MACHINE TYPE : Xg series
SOFTWARE VERSION: System V1.40
CLASSIFICATION : Installation
REFERENCE : H9345, MC10140

No: SI261E-001
ISSUED DATE: June 2, 2006
LAST UPDATED: September 25, 2012

Procedure for replacing from 12 inch touch panel to 15 inch touch panel

Figure 1

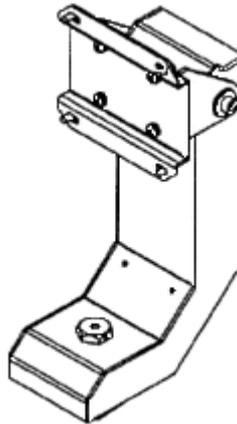
1. Replace the existing mounting plate with the one for the 15-inch touch panel.

Note:
As the screen size of the 15-inch touch panel is larger than the 12-inch one, it may interfer with the safety cover. Replace the existing mounting plate with the one for the 15-inch touch panel.

Figure 2

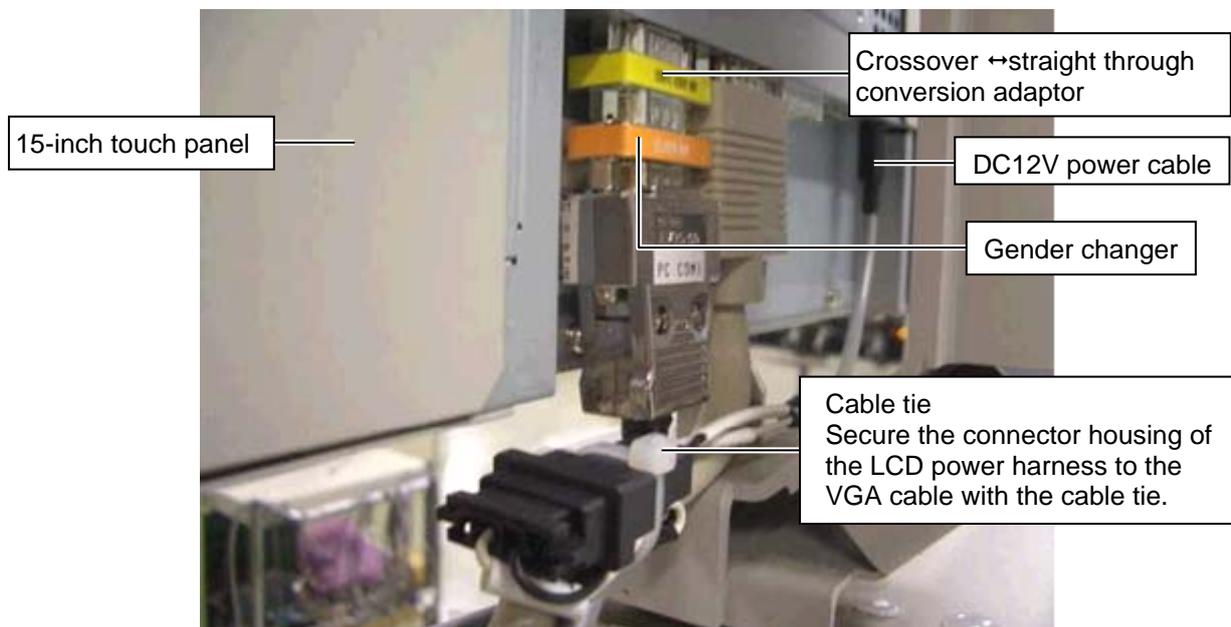
2. Attach the other spare parts referring to the figure below.

Cable tie
Secure the connector housing of the LCD power harness to the VGA cable with the cable tie.
